DA 1326/2015: 11 – 15 Holborn Circuit, Gledswood Hills

This memo has been prepared in response to the email dated 21/01/2016 from Ryan Pritchard, Executive Planner of Camden Council and subsequent design changes to the proposed Health Hub development known as DA 1326/2015: 11 – 15 Holborn Circuit, Gledswood Hills.

PROJECT NAME:
GREGORY HILLS HEALTH HUB

Figure 1 – Temporal Distribution of Parking Demand Based on Land Use

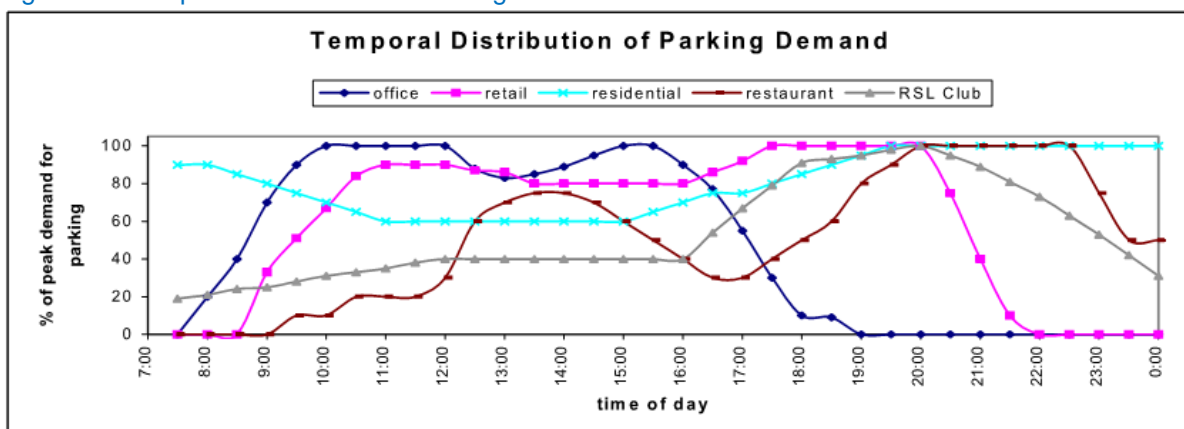
Figure 1 presents varying peak operating periods for land uses that are nominated to be situated within the proposed Health Hub site and comment 2 provides an understanding of the cumulative impact from varying peak parking demands generated from the different uses contained within the proposed Health Hub.

Observations and appraisal of data obtained for other site uses highlights that when the restaurant is operating at its peak the remaining key areas of the health hub, such as the private consulting rooms, will either be closed or operating at a reduced capacity (say 50% of its potential capacity). This operation trend for private consulting rooms was observed to occur at established health hub practices situated in Randwick and St Leonards. This difference in peak operational patterns allows the parking provision for the selected land uses within the health hub to be better optimised through an asset sharing arrangement, and in doing so provides a more sustainable outcome in the planning for the Health Hub.

DRAWING TITLE:
GROUND FLOOR PLAN

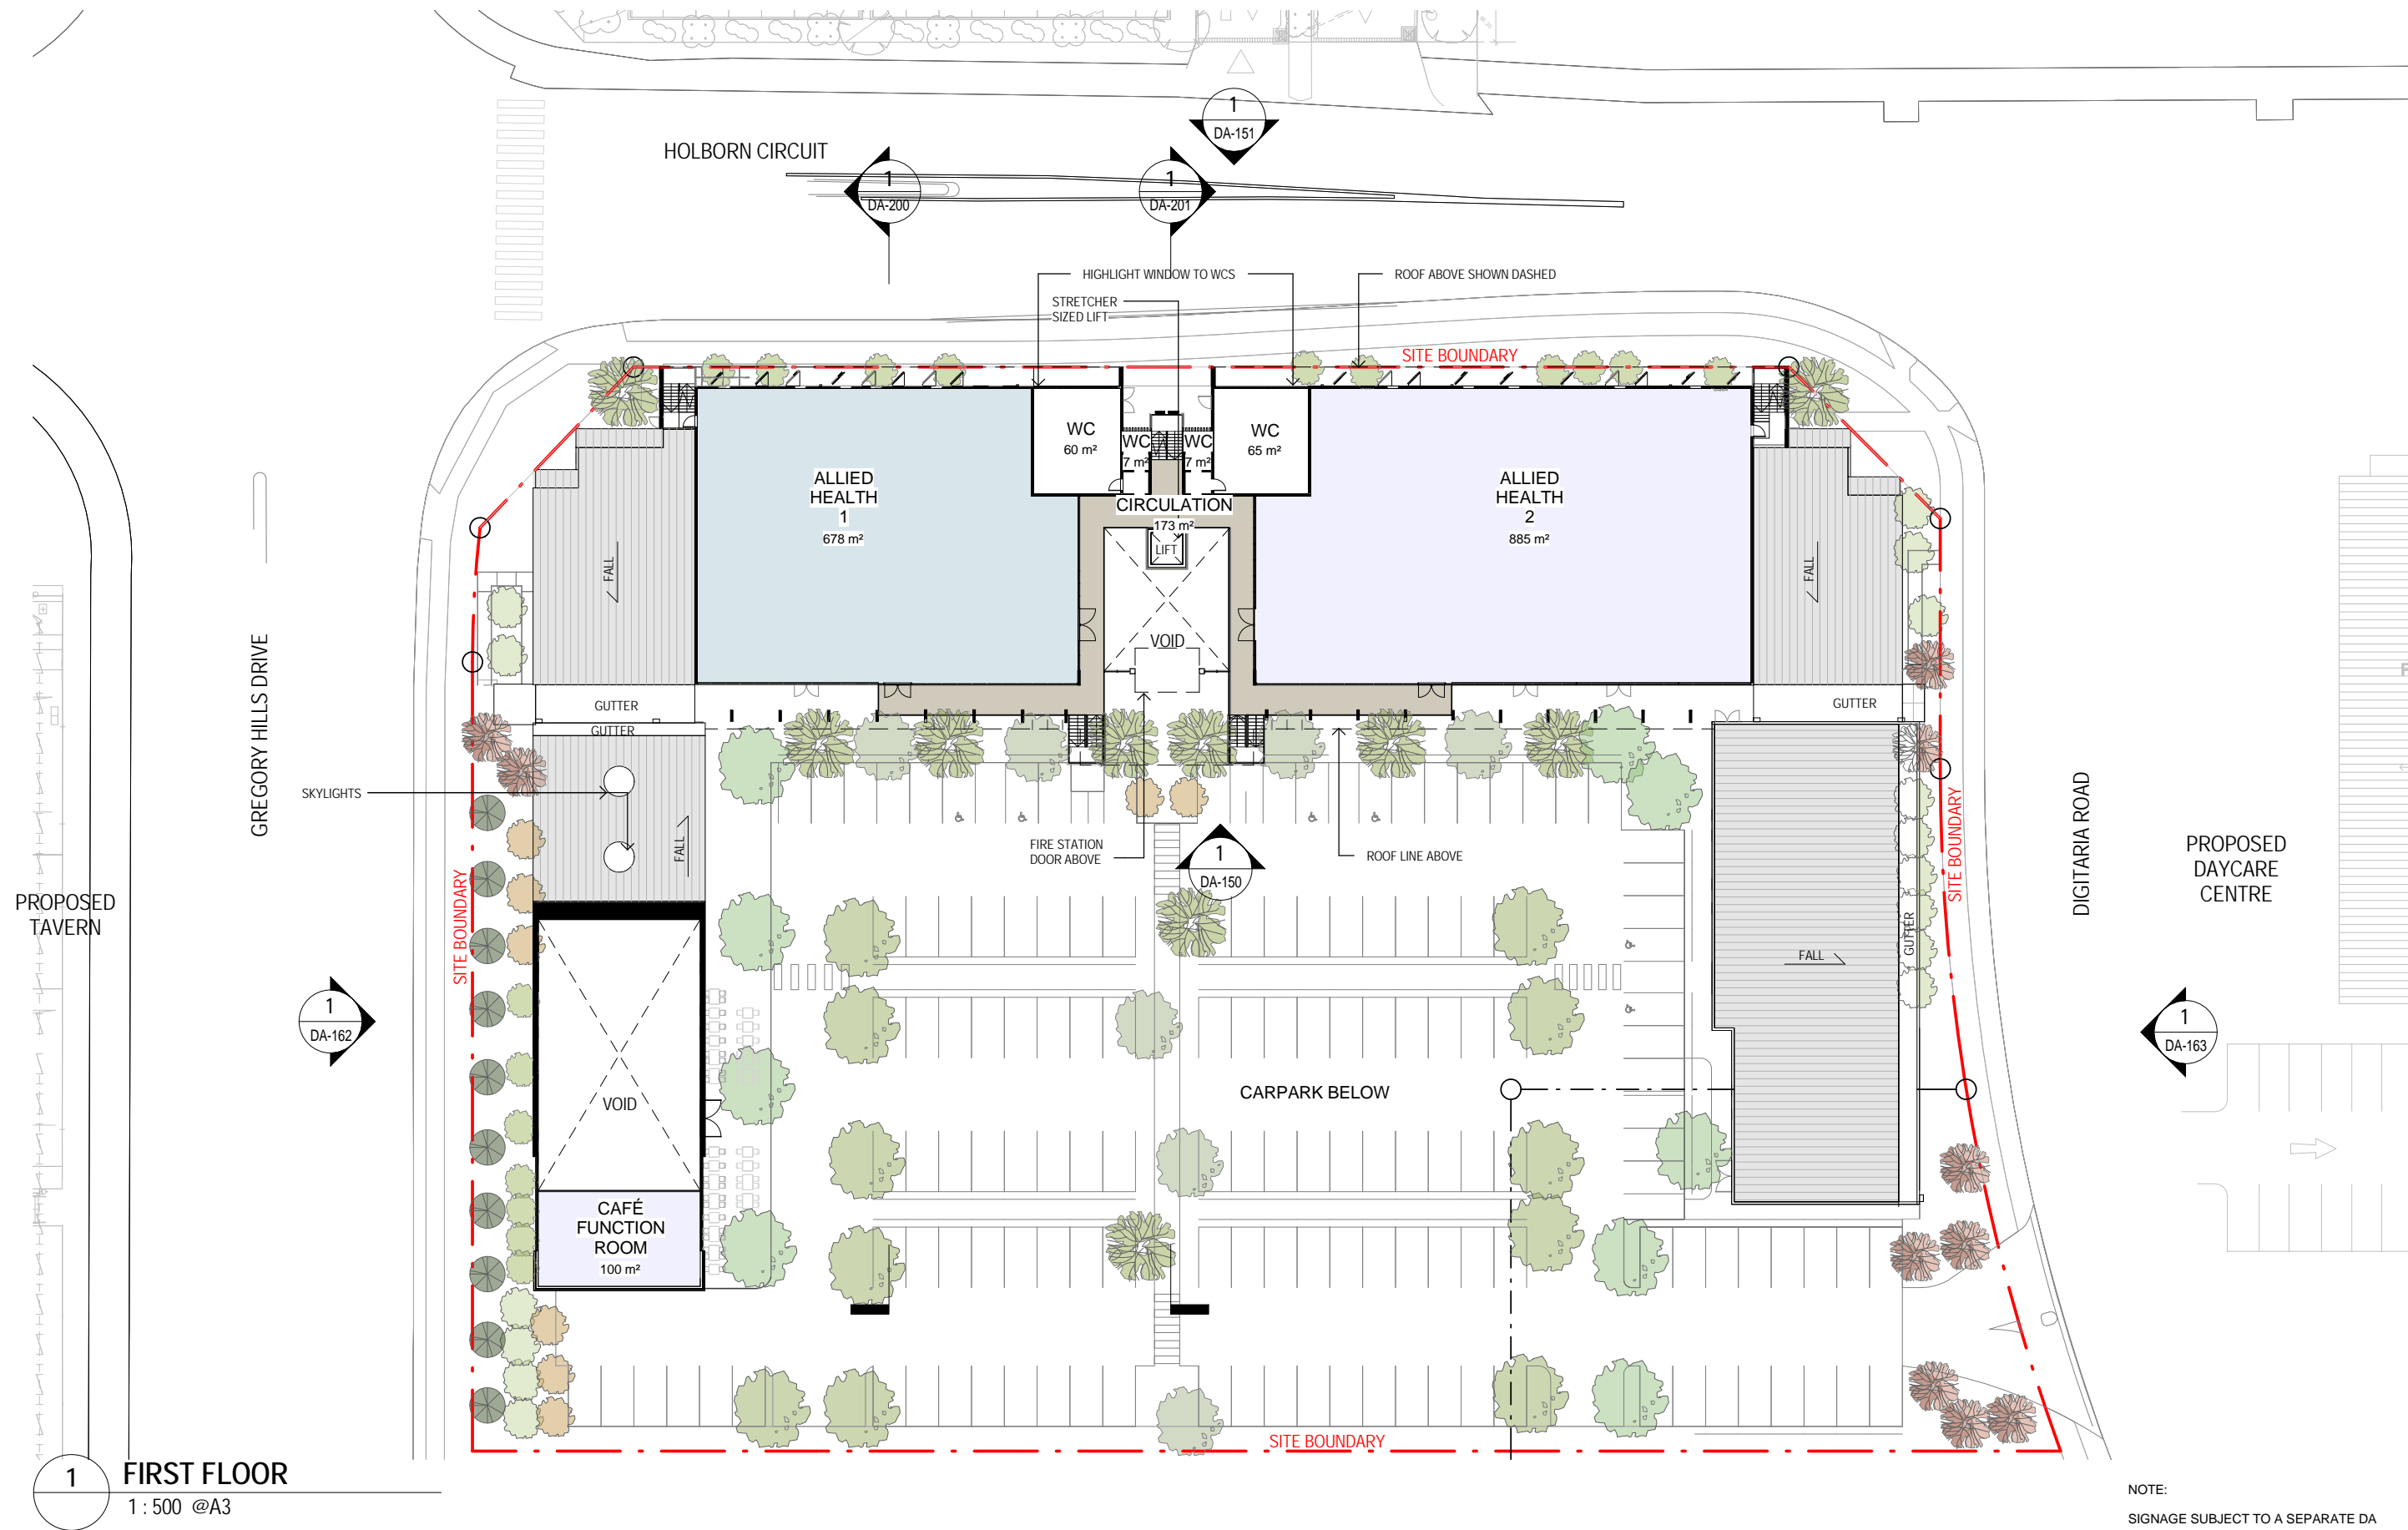
6. Parking space spatial provision and compliance with AS 2890.1

The attached design (refer to Appendix A) has been amended to align with the standard and provides a 600mm overhang from the kerb for each parking space, with a low landscaped area kept free from footpaths and obstacles. This arrangement prevents vehicles from impacting on footpaths and colliding with other potential obstructions.

A total of 3 loading zones have been provided internally to the site as indicated in Appendix A. These are located:

- At the rear of the restaurant in the south-east corner of the car park – designated and will be managed by the restaurant.
- In the plaza area situated in the south west corner of the site and fronts the restaurant, Allied Health and chemist (accessed via a roll-top kerb)
- Situated in the car parking area at the north eastern corner of the site adjacent to the bulky goods land uses (composed of time-restricted parking spaces)

Figure B1: Service Vehicle Path for Loading Zone at Front of Restaurant and Chemist

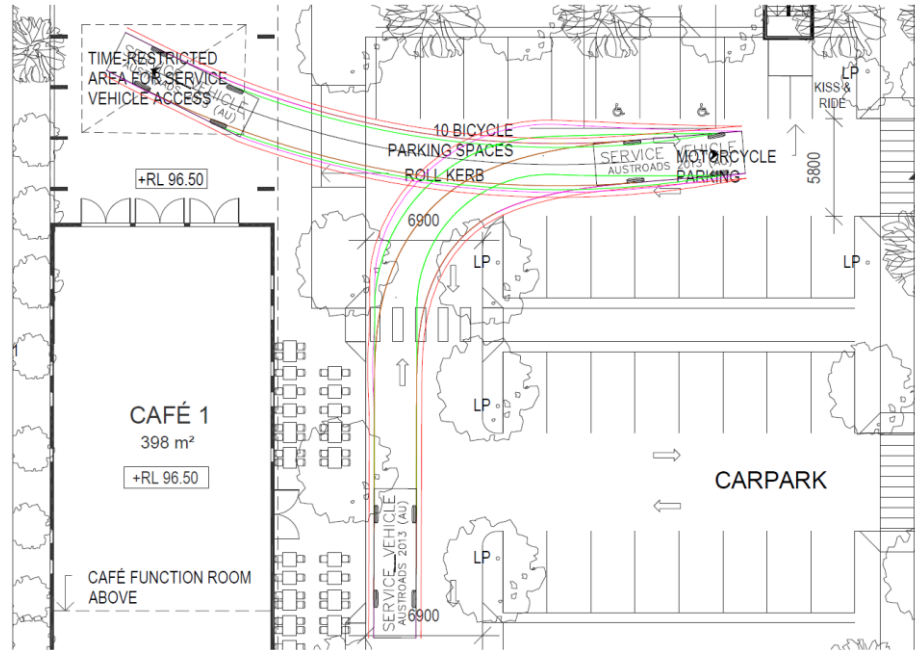
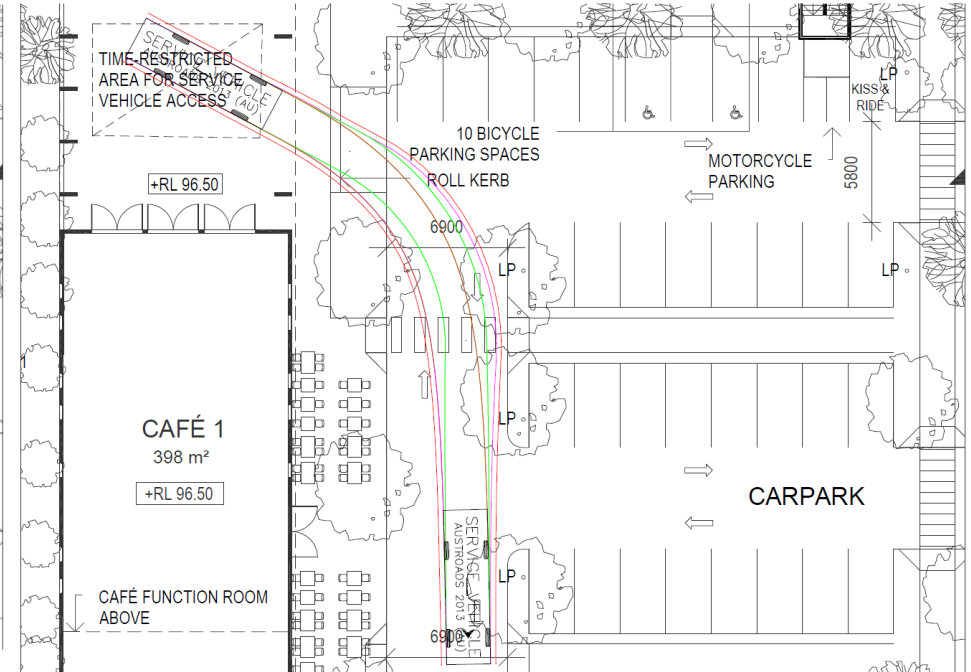
These areas are accessible by an 8.8m medium rigid service vehicle (MRV) as demonstrated by the turning path assessment presented in Appendix B. It is noted that these loading zones will not be used concurrently and the associated demand generated is infrequent. On this basis the proposed solution is deemed to be appropriate for all land uses associated with the proposed health hub development.
